K&A ARCH COMMENTS :

PROJECT: JEDDAH OPERA HOUSE

TITLE: CARPARK BUILDING
VERTICAL TRASNPORTATION
PART 002
PLANS - ELECTRICAL ESCALATORS (ESC 1& ESC2)

DRAWING No: JOH-OTS-S5-01-015-002-ZZ-SD-VT-011030 REV: S01

Escalator

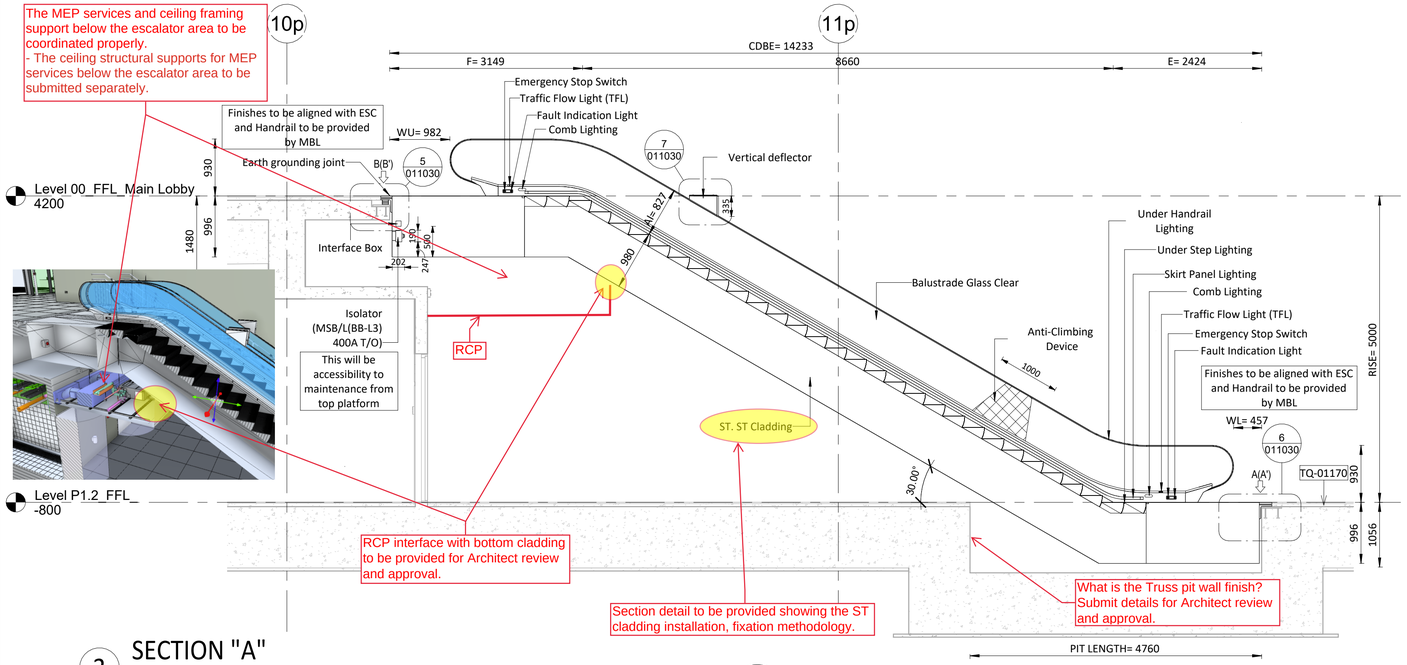
The MEP services and ceiling framing support below the escalator area to be coordinated properly.
- The ceiling structural supports for MEP services below the escalator area to be submitted separately.

3 SECTION "A"
1 : 50

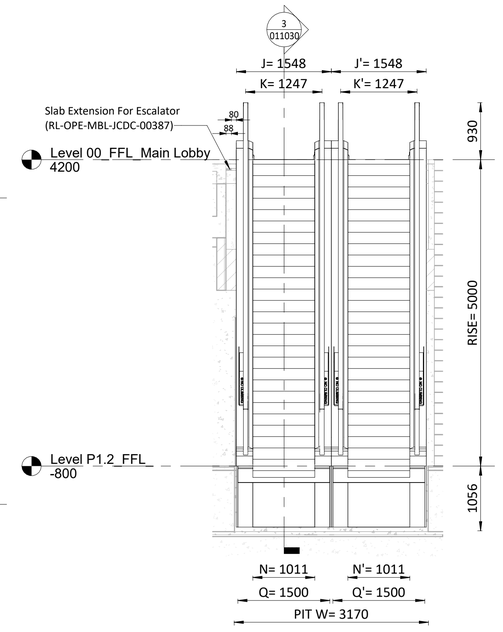
RCP interface with bottom cladding to be provided for Architect review and approval.

Section detail to be provided showing the ST cladding installation, fixation methodology.

What is the Truss pit wall finish? Submit details for Architect review and approval.
